Product Change Notification

Date Issued :	September 22, 2022	PCN Number :	512671
Reason for Change :	Change Supplier		
Description of Change :	New Supplier Addition: This notification is to inform you about addition of new Supplier or Sub Supplier impacting the part(s) as per attached list. No changes will be made to product as part of this change		
Reason for Short Notice :	Special Request		
Assessment of Change :	Reliability Test Report/s First Article Inspection		
Planned Implementation Date :	January 31, 2023		
Sample Availability Date:	September 12, 2022		
Internal Molex Qualification Date :	October 01, 2022		
Last date to request Samples by Customer :	December 22, 2022		
Traceability Code Markings / Date :	Special marking on the product or packaging

- 5024390400 2.0 W/B Single Plug Hsg 4Ckt
- 5024390600 2.0 W/B Single Plug Hsg 6Ckt

5024390400

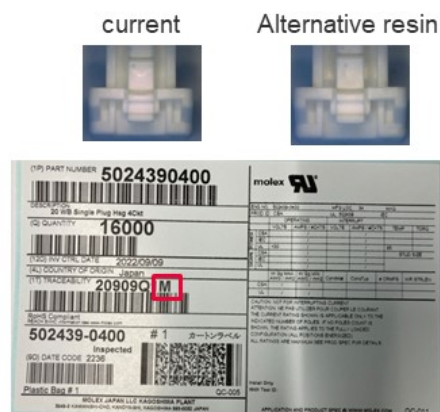
Change point: we will add alternative resin.

Resin (Raw material) : PBT UL94V-0 COLOR:WHITE

- Brief description of change:
 - Add alternative resin for 5024390400 and 5024390600 production.
 - The resin type of the alternative resin is "PBT UL94V-0" which is same as current resin.
 - After applying of this change, Molex products listed above will be manufactured by one of them - the current supplier's material or the alternative supplier's one by the resin material supply situation.
- Reason for Change:
 - To ensure the stable supply of the products against worldwide material shortage issue.
- Product Impact:
 - Almost no see shade difference.
 - Also, there is no affect to form, fit or function.
- Identification:
 - For the first 6 months of the production start by the alternative material, we will add "M" at the end of Traceability number of the carton label to identify products made from alternative materials.
